1 We emphatically oppose the SD15 Property Specific Request for rezoning and General Plan Amendment. Further, we respectfully do not believe that this EIR provides a complete or accurate picture of the property's context or impacts of this project.

- I13-1 This comment states that Perkins Ranch opposes the proposed rezoning of PSR Analysis Area SD15 and states that the commenters do not believe the Draft SEIR provides a complete or accurate picture of the property's context or impacts of the project.

Screenshot of San Marcos Open Space<sup>1</sup>

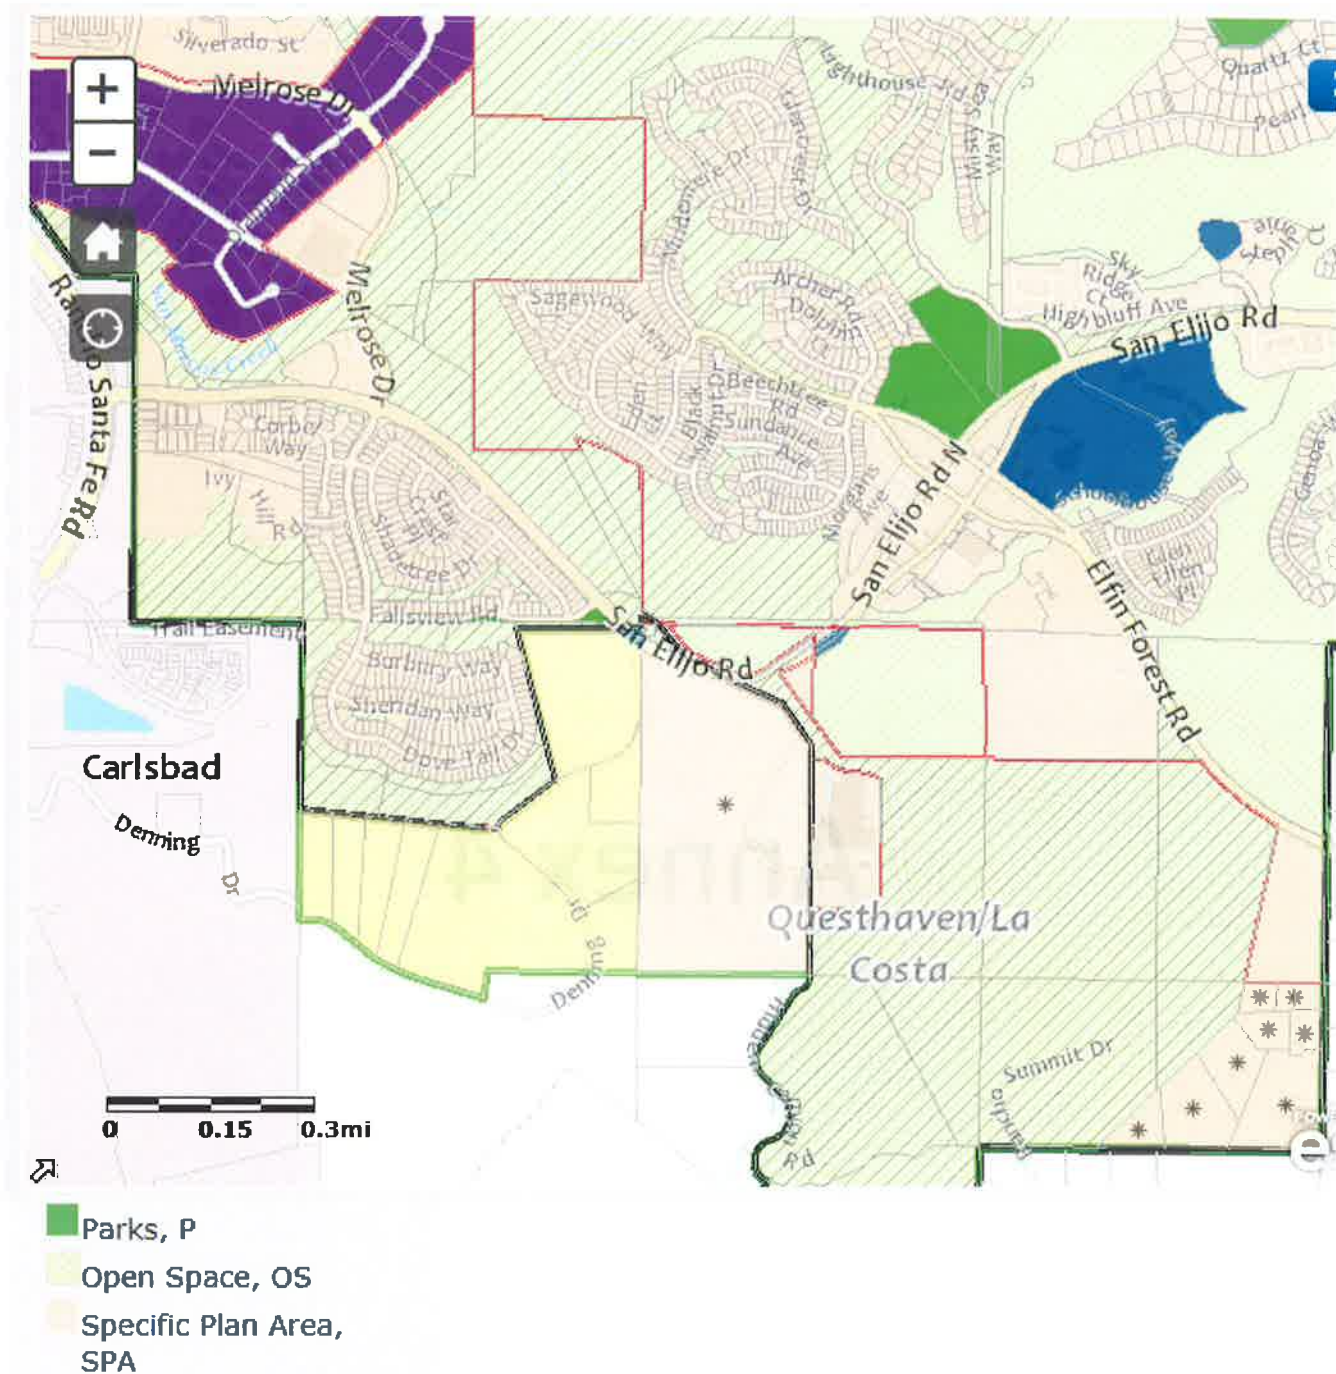
- 21 This property serves as an important connector/corridor from the County Core to the San Marcos habitat areas. Please see Annex 3 for a map of preserved areas within San Marcos that were not considered in this EIR.<sup>4</sup> Development of this property as proposed will fragment the habitat and decrease habitat connectivity between the County and San Marcos. Edge effects will harm neighboring habitats and fuel modification arrangements will cut into habitat. Light and glare effects will affect neighboring preserves.
